#### **ADDENDUM #3**

PROJECT: CODESTACK ACADEMY

REF. # : ARCH PROJ. No. 2023-04

DATE: 27 November 2024

ADDENDA #1 11.05.24 PROJECT NO: 2023-04

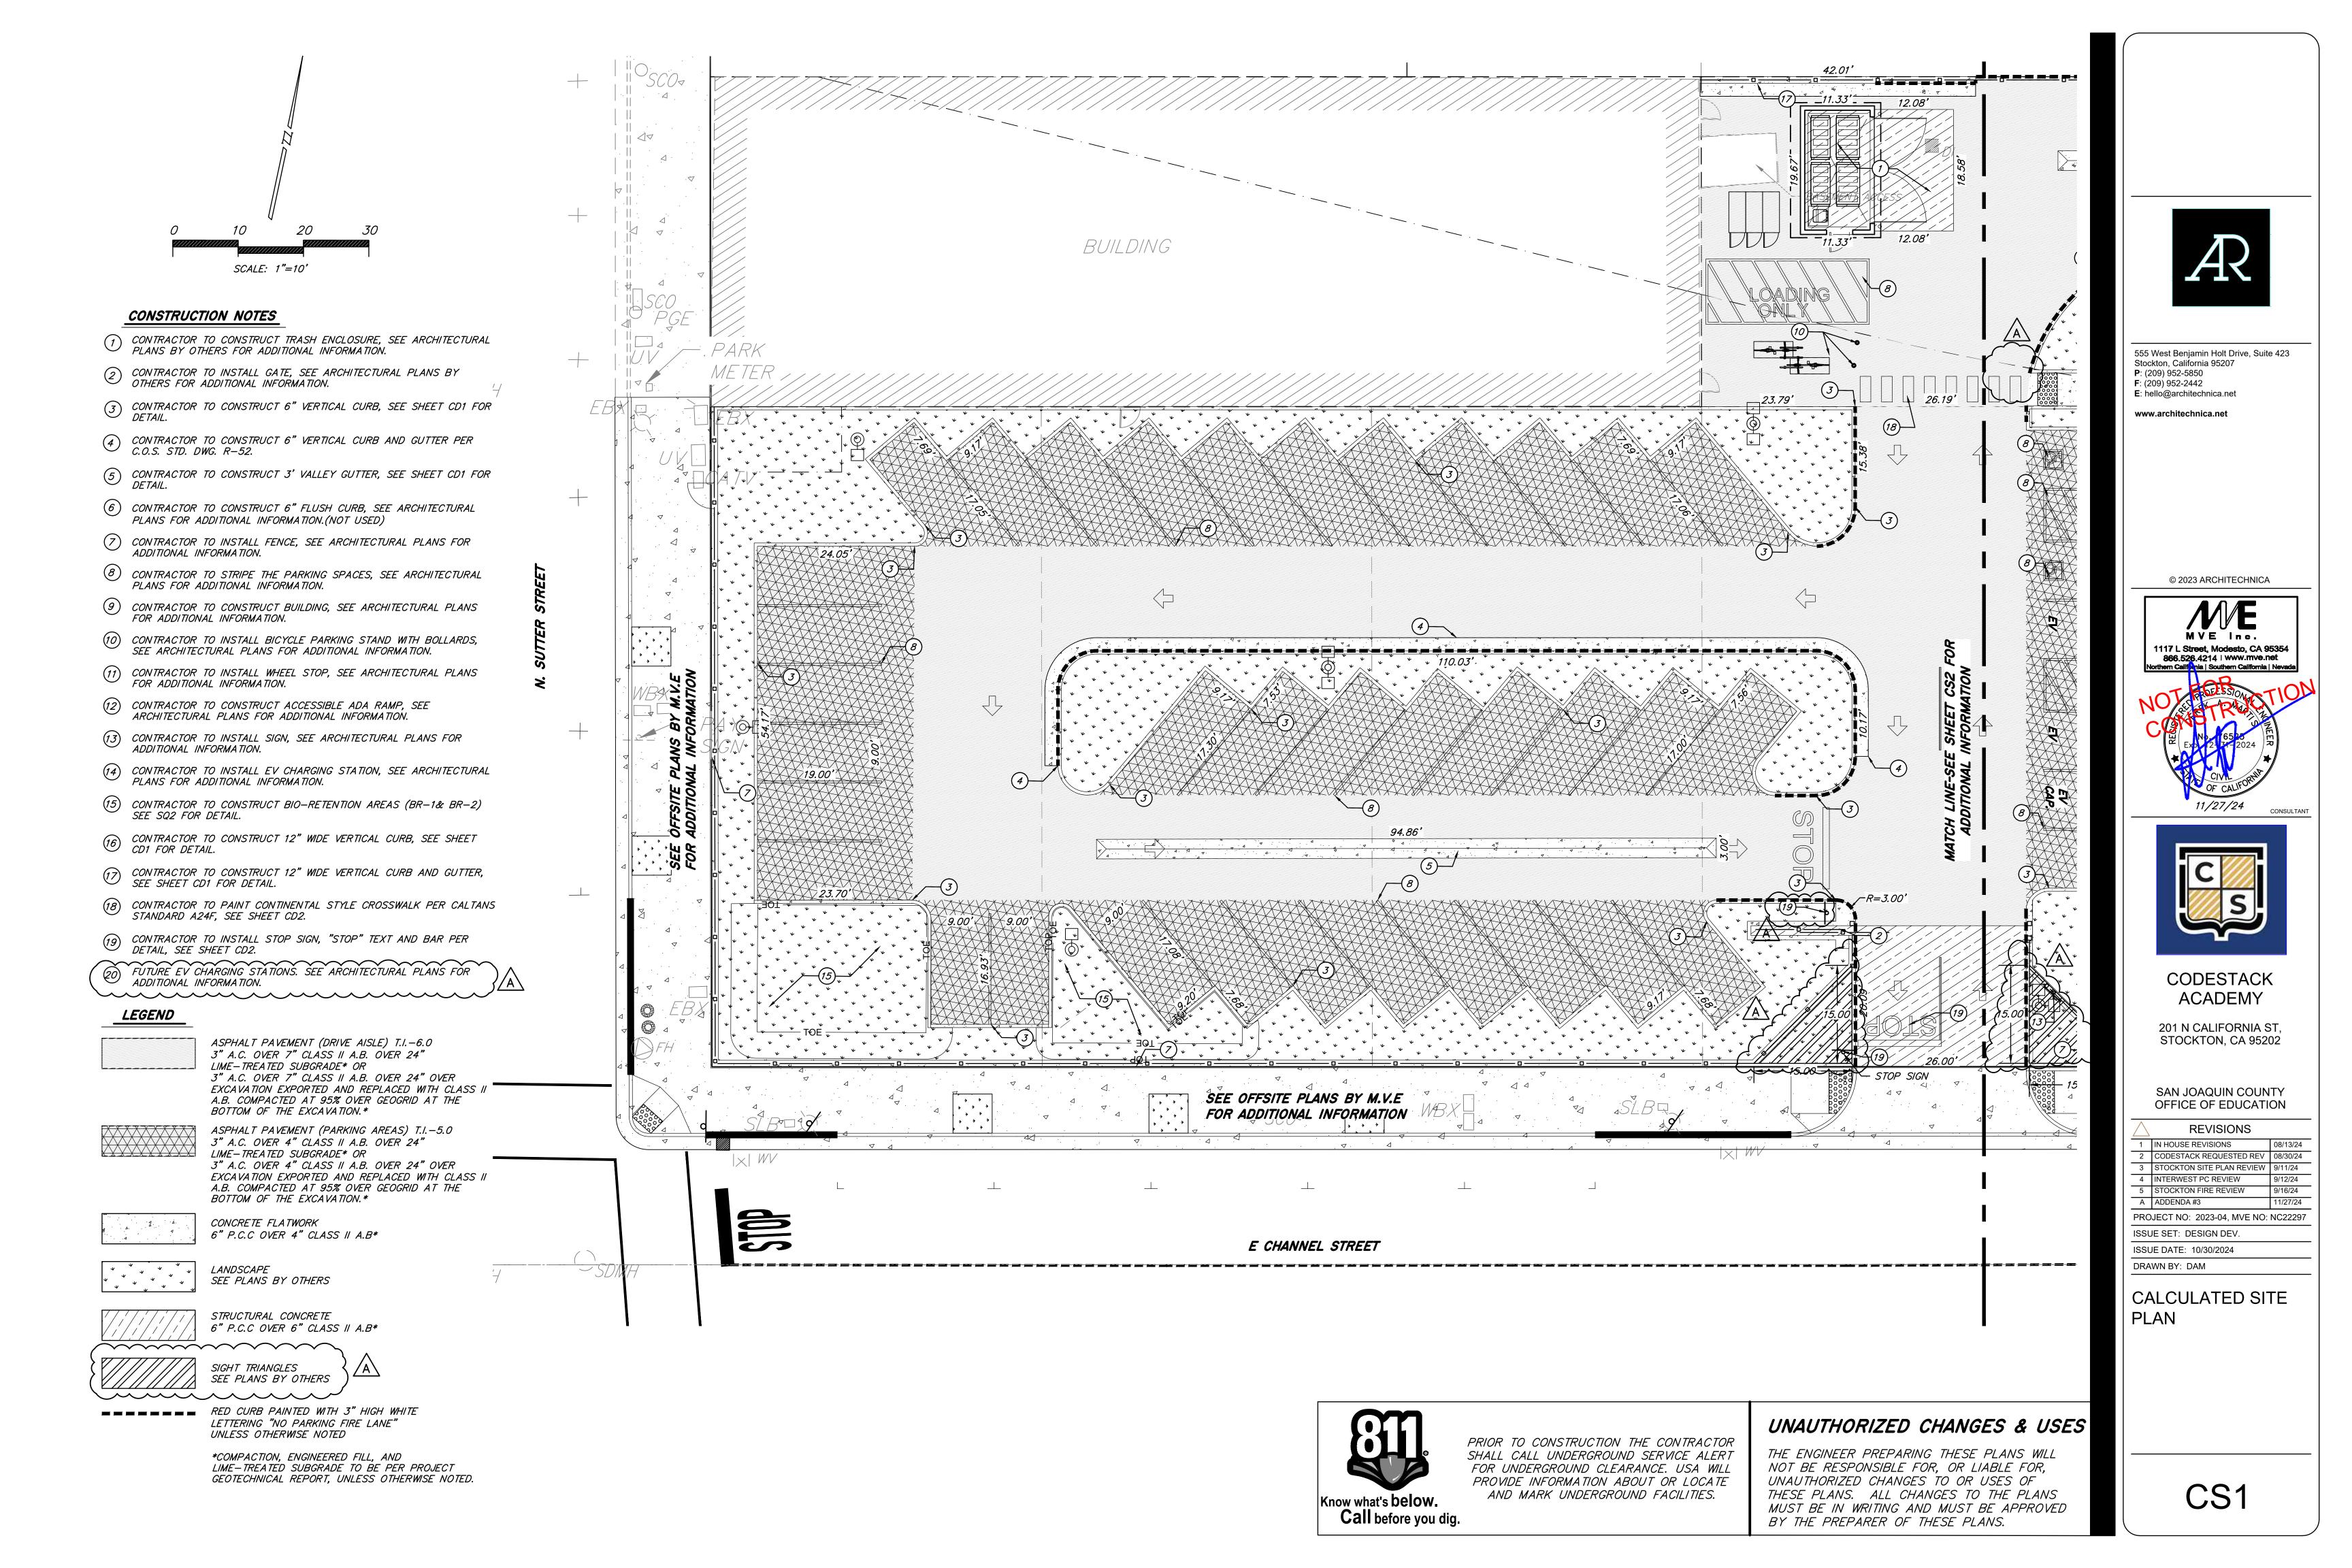
#### ITEM 4 A9.2.11

Added detailing for beam to wall. Detail 16.

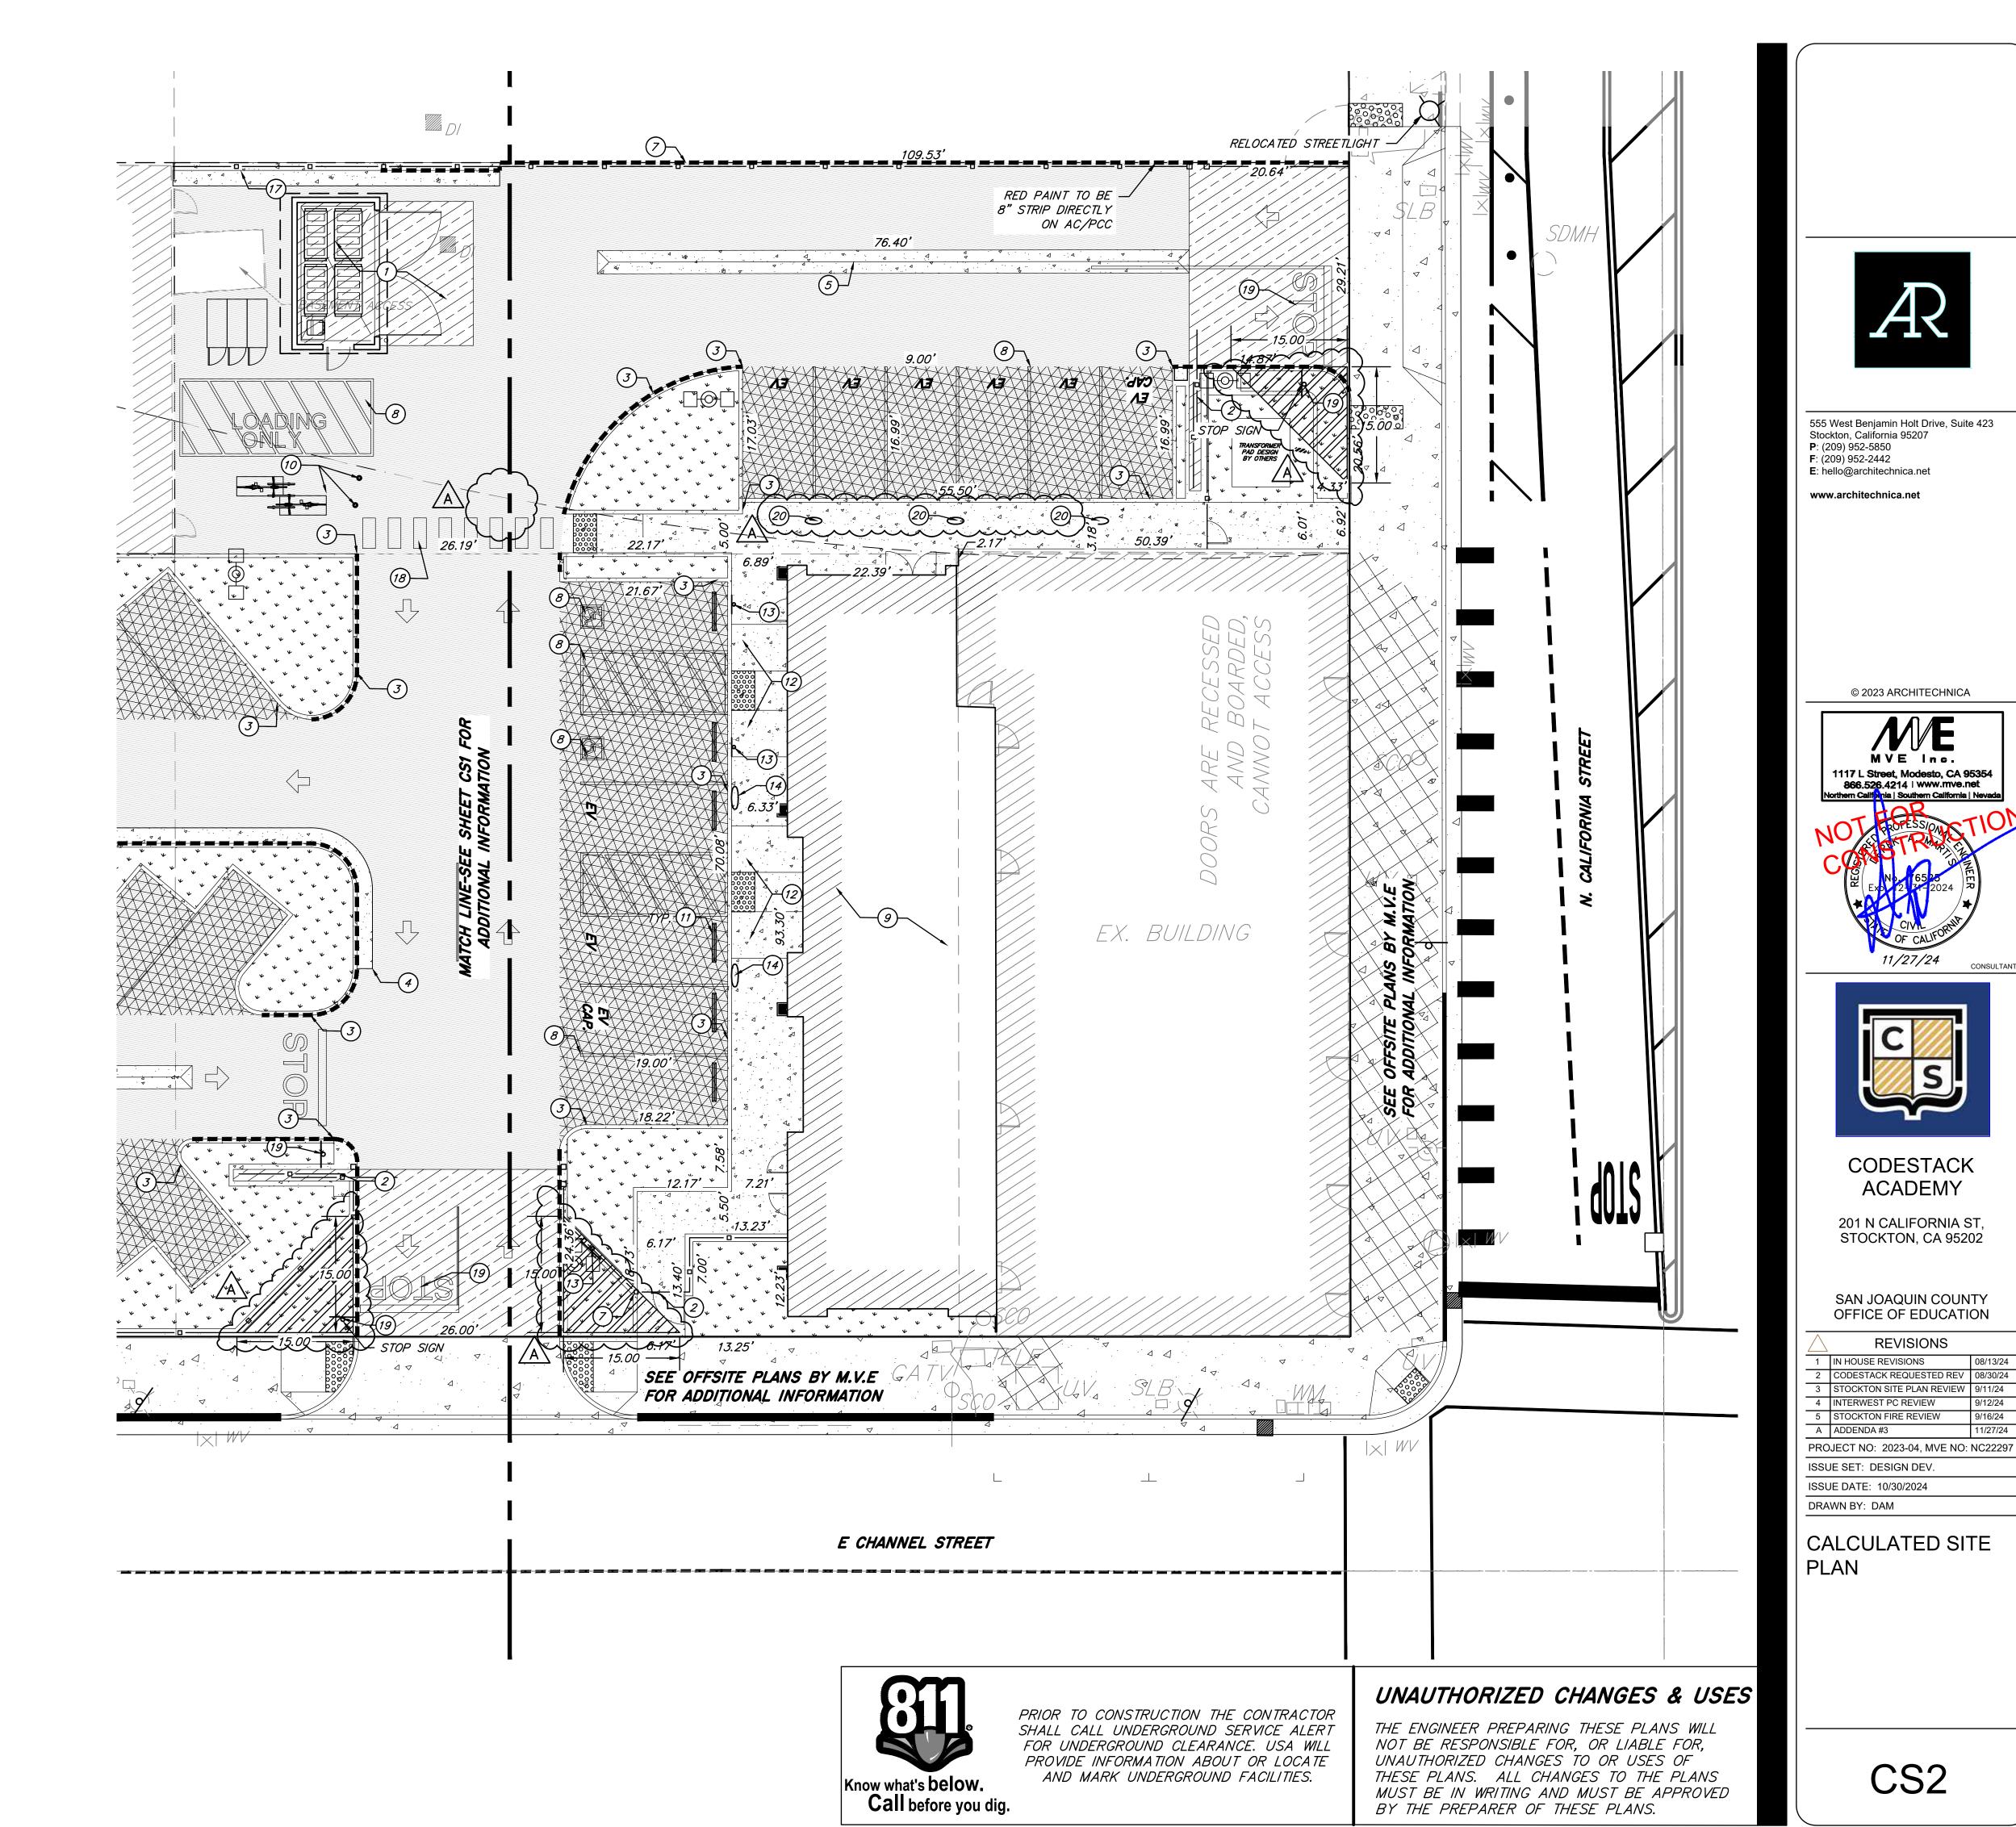
#### ITEM 1 Sheets CS1, CS2:

- Revise Signage callout for Stop sign
- location of tow away sign moved to fence
- Add note #20 for FUTURE EV Charging stations. Stations at North of parking lot noted as FUTURE EV charging stations.

UT1

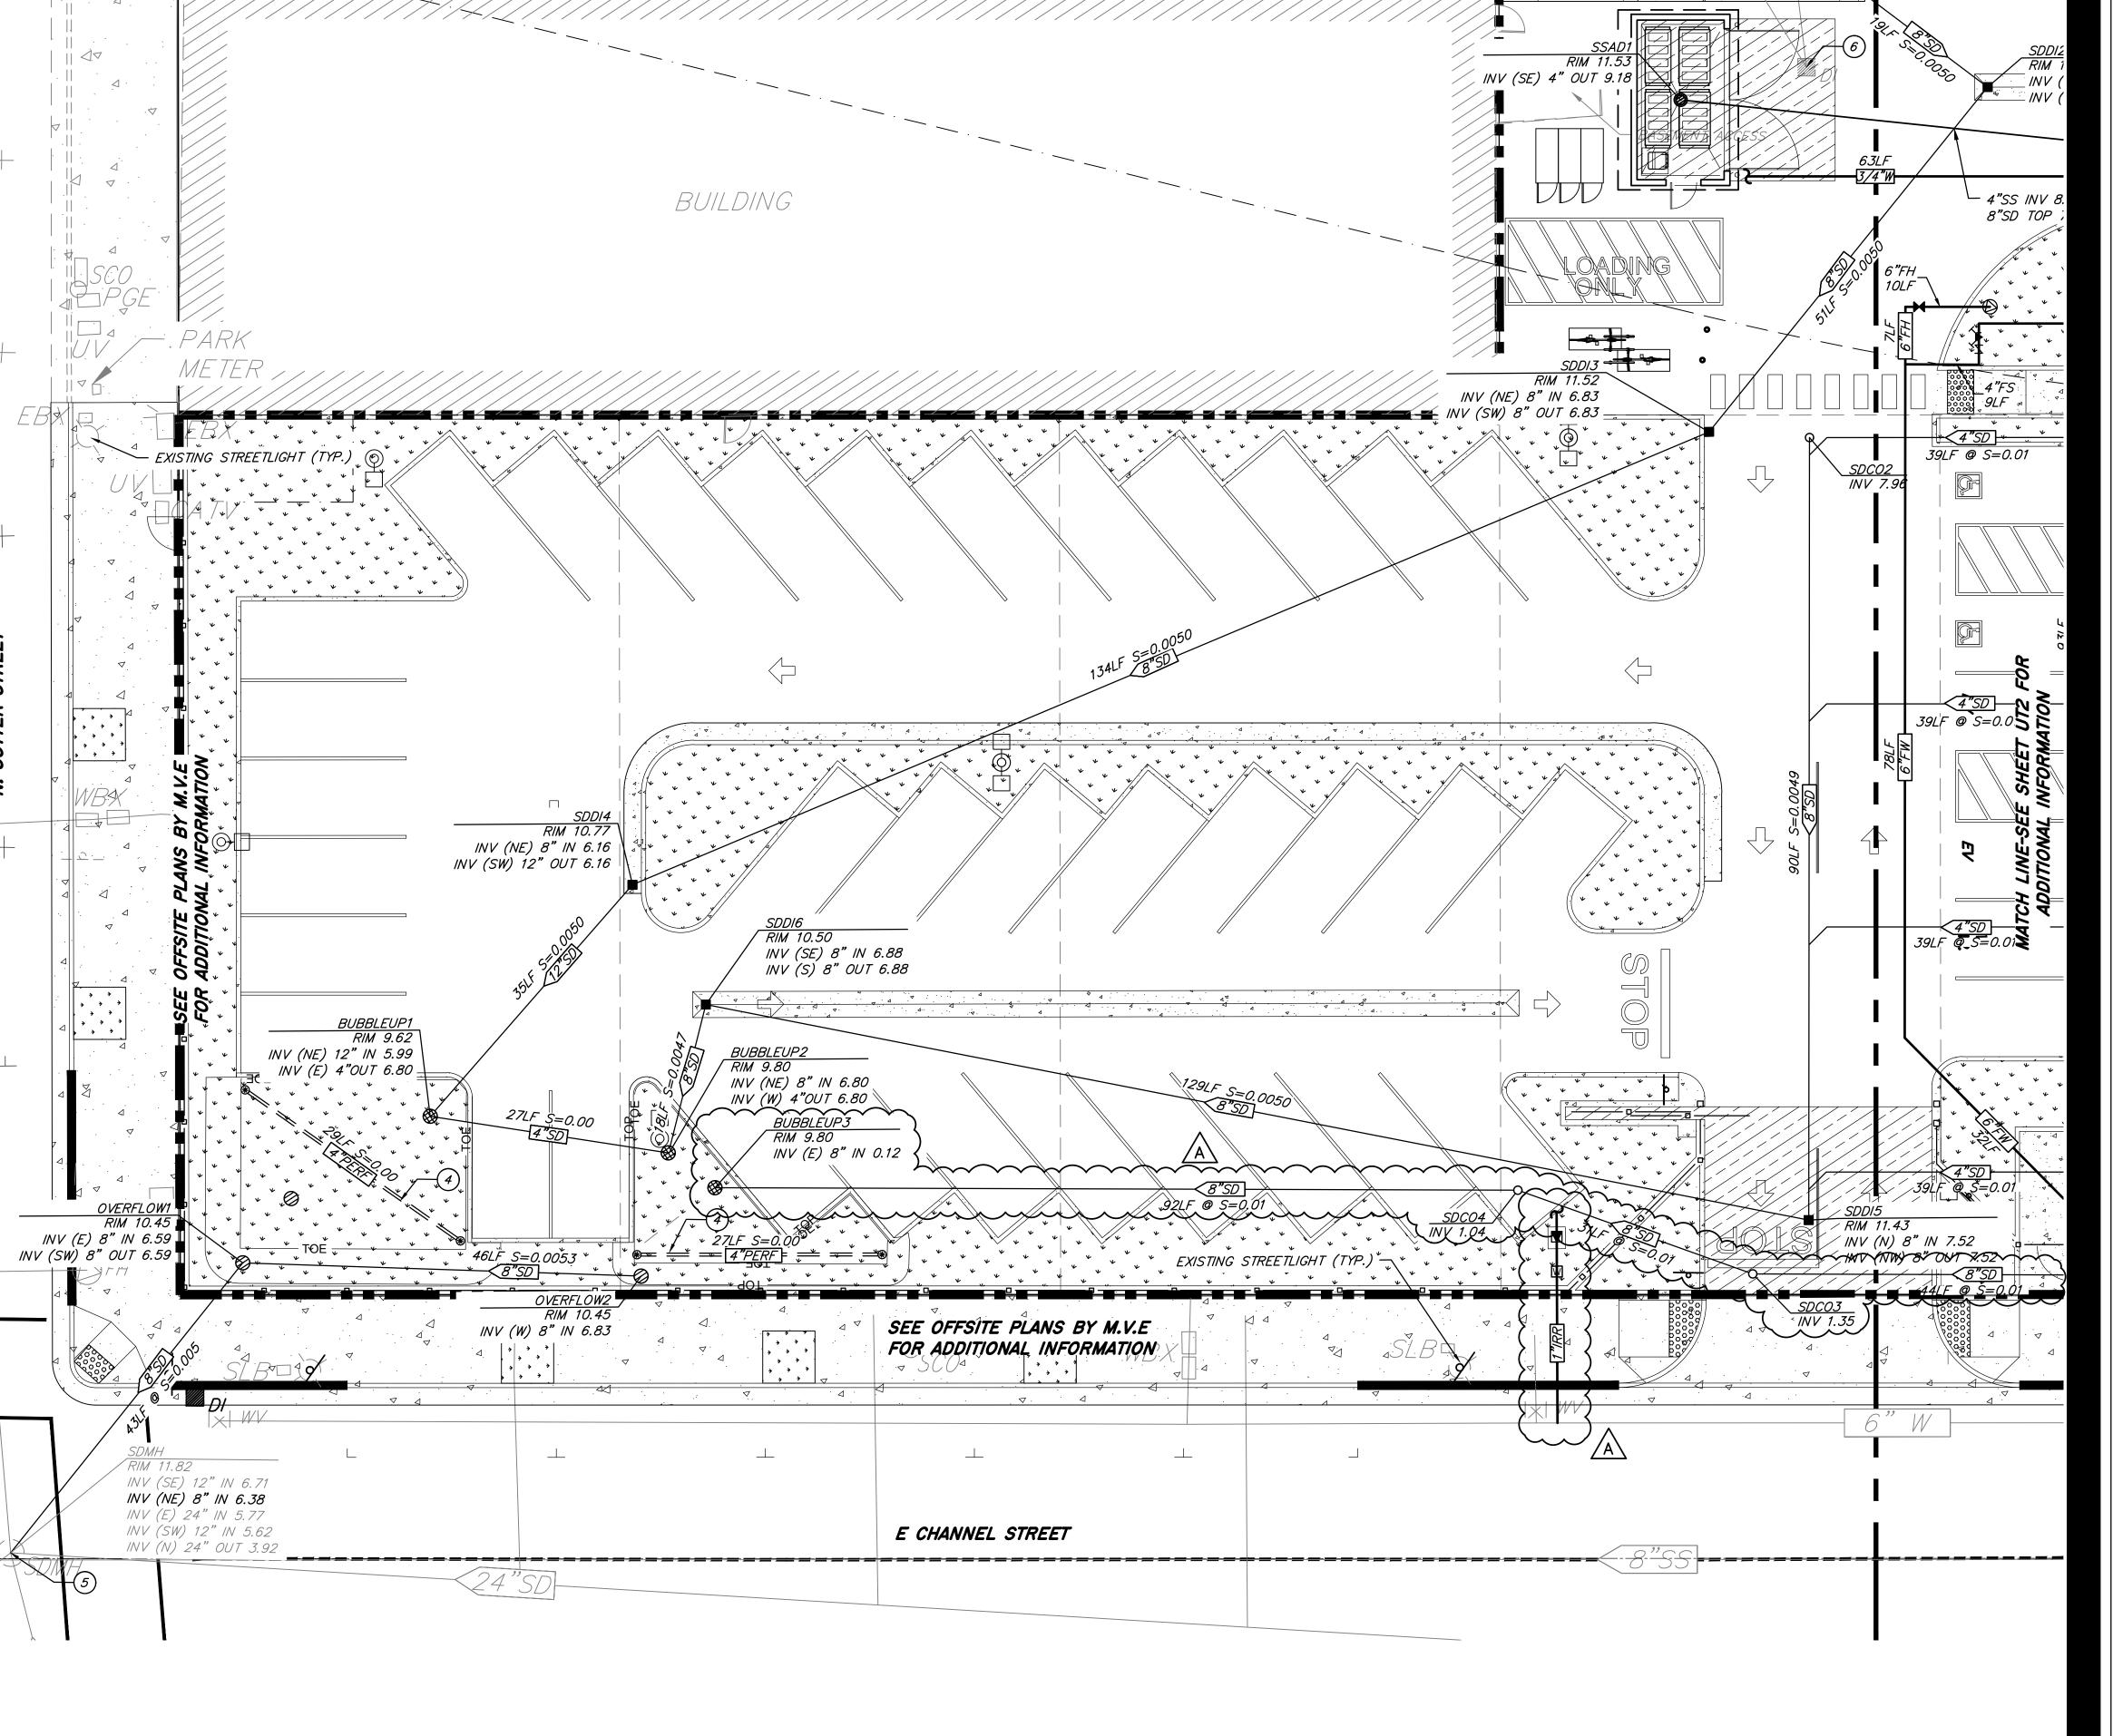
#### ITEM 2 Sheets UT1, UT2:

- Water Service Sizing Coordination with Plumbing and Landscape
- Add/ Identify drainage route for Building Perimeter drain (Sheet UT1)
